SETTLEMENT AGREEMENT EXHIBIT D PART 3

Case 5:16-cv-07013-LHK Document 375-7 Filed 10/07/19 Page 1 of 3

600 Level Accessible Route of Travel and Accessible Signage

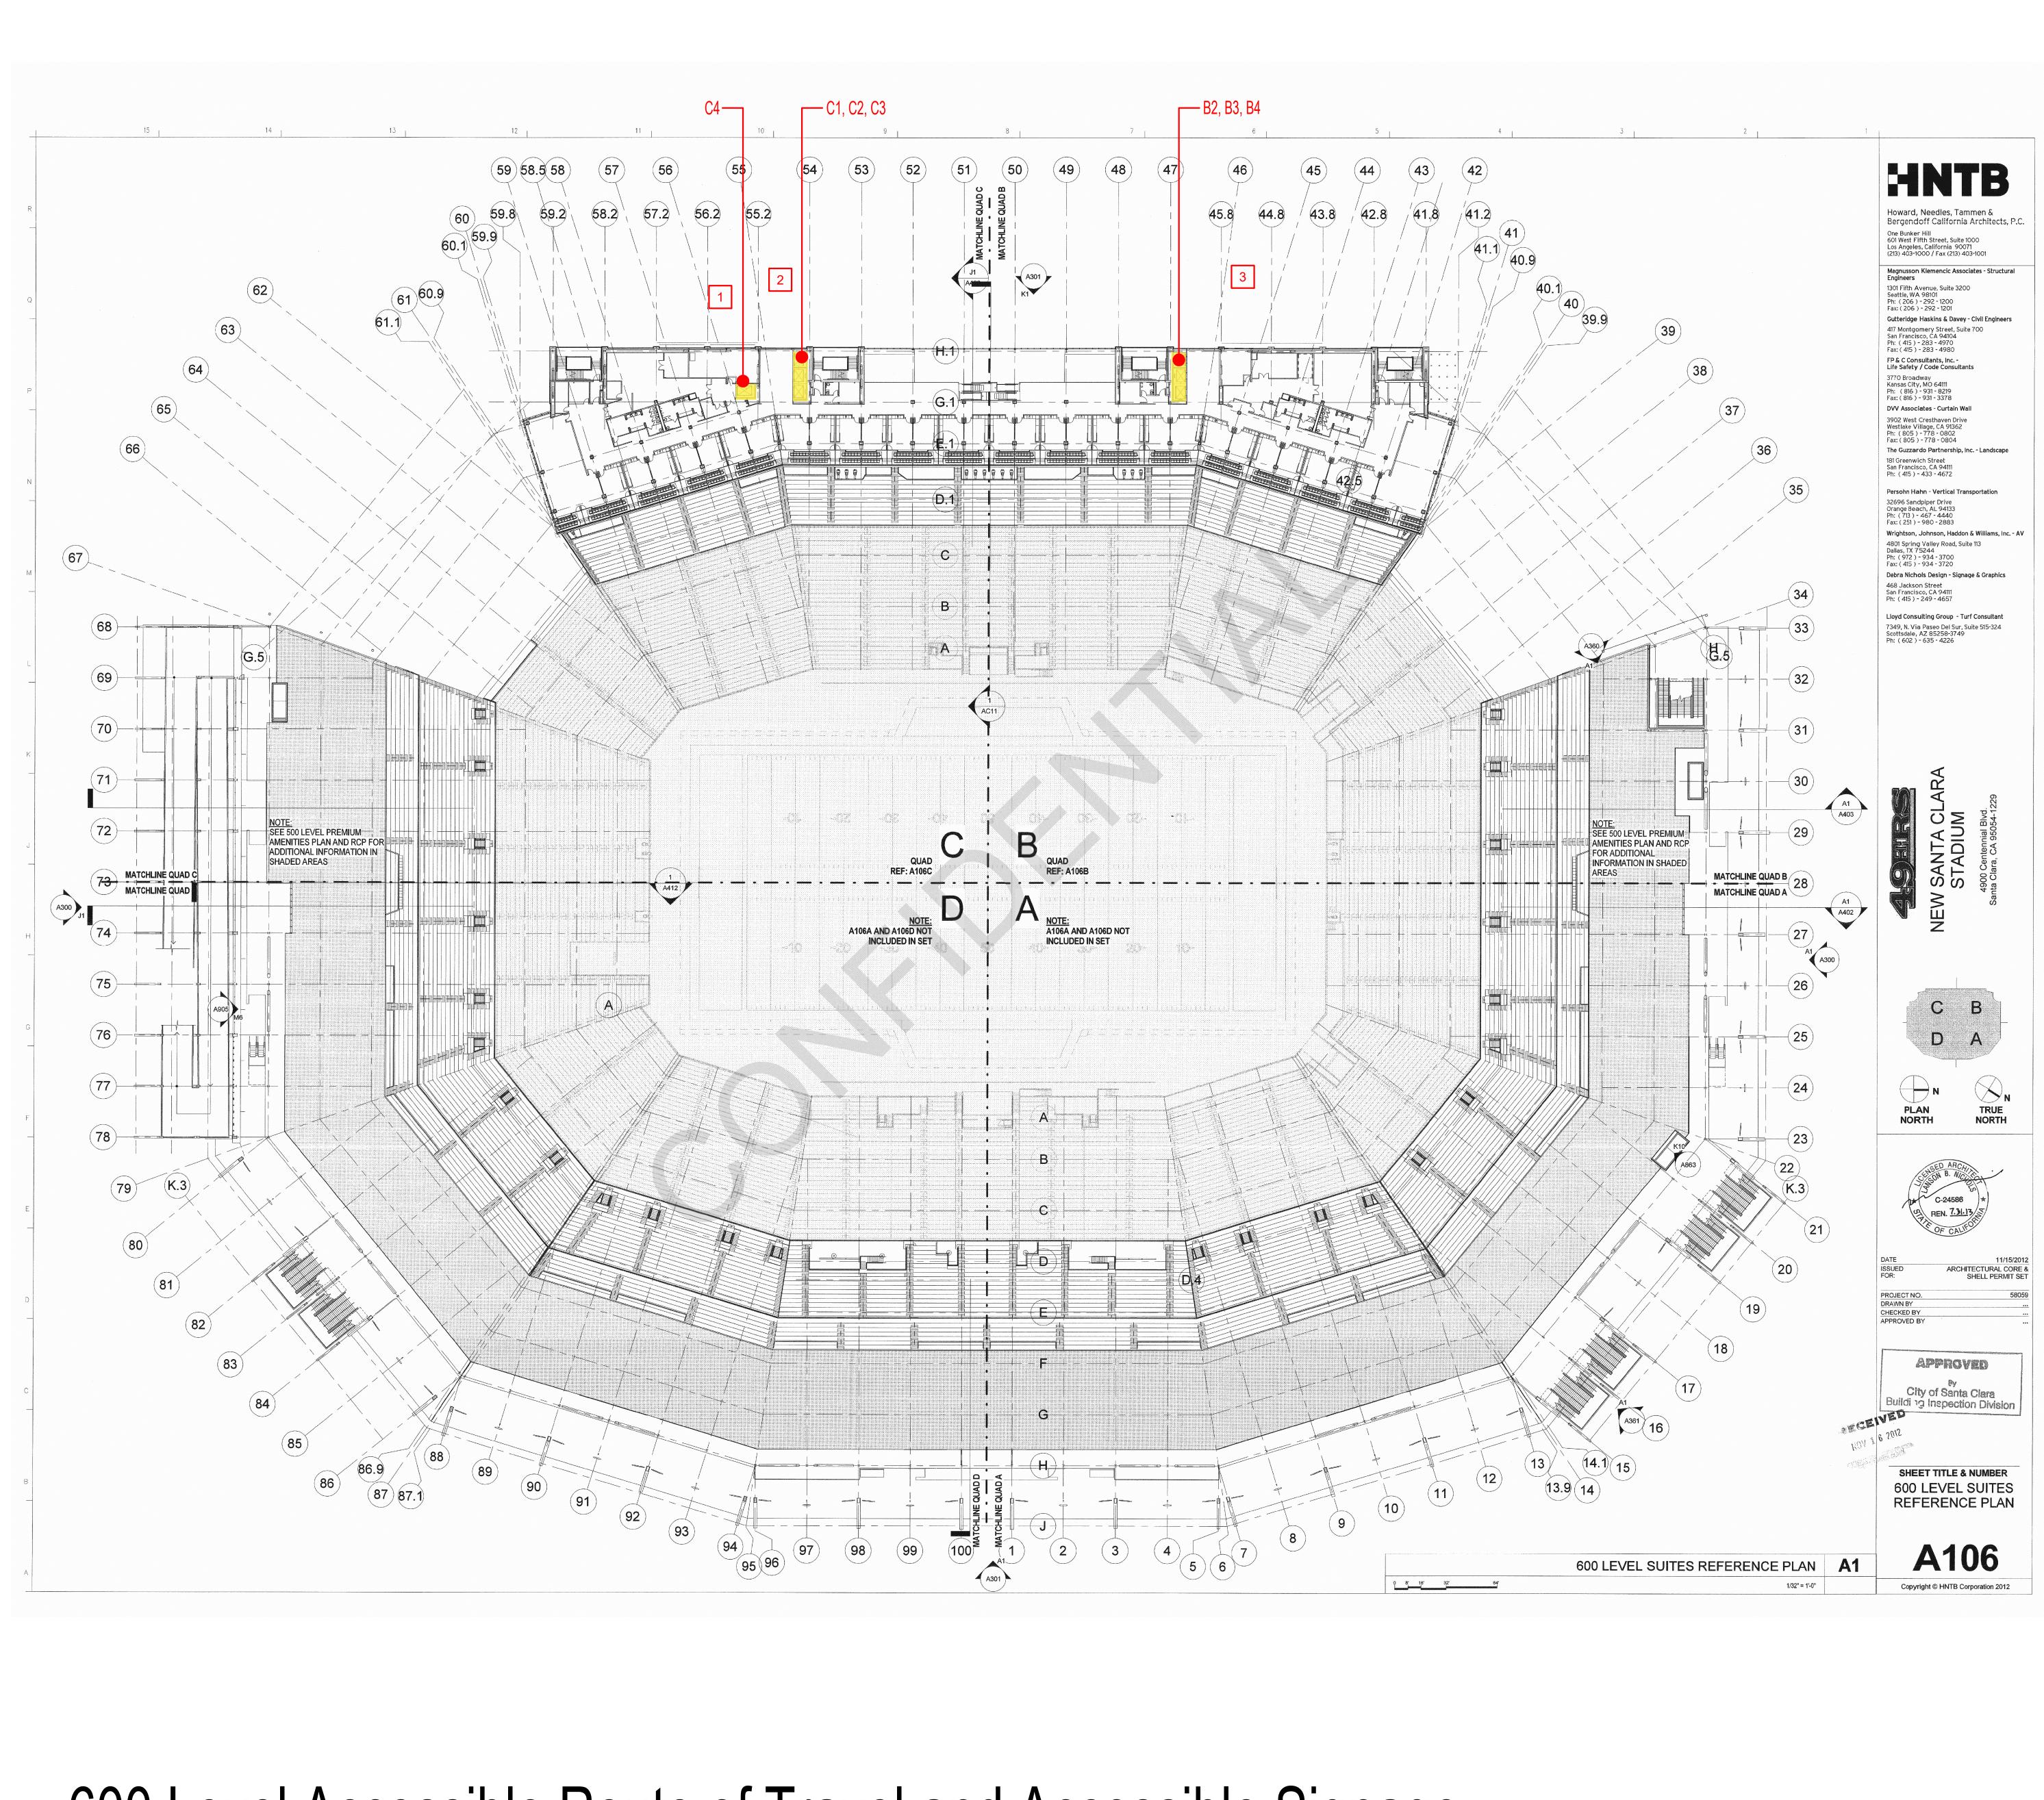
AT THE APPROACH TO ELEVATORS C1, C2, & C3 PROVIDE SIGNAGE AT A LOCATION CLEARLY VISIBLE TO PERSONS WITH DISABILITIES USING A WHEELCHAIR THE LOCATION OF ELEVATOR C4 AND INDICATE IT SERVES THE NRG TERRACE. ALSO PROVIDE SIMILAR SIGNAGE AT THE DOOR LEADING TO THE LOBBY OF ELEVATOR C4.

AT ELEVATORS C1, C2 & C3 PROVIDE SIGNAGE AT A LOCATION CLEARLY VISIBLE TO PERSONS WITH DISABILITIES USING A WHEELCHAIR AND INDICATING THE STADIUM LEVELS THEY SERVE.

3 AT ELEVATORS B2, B3 & B4 PROVIDE SIGNAGE AT A LOCATION CLEARLY VISIBLE TO PERSONS WITH DISABILITIES USING A WHEELCHAIR AND INDICATING THE STADIUM LEVELS THEY SERVE. SIGNAGE SHALL ALSO INDICATE THE ELEVATOR B2 SERVES THE NRG TERRACE.
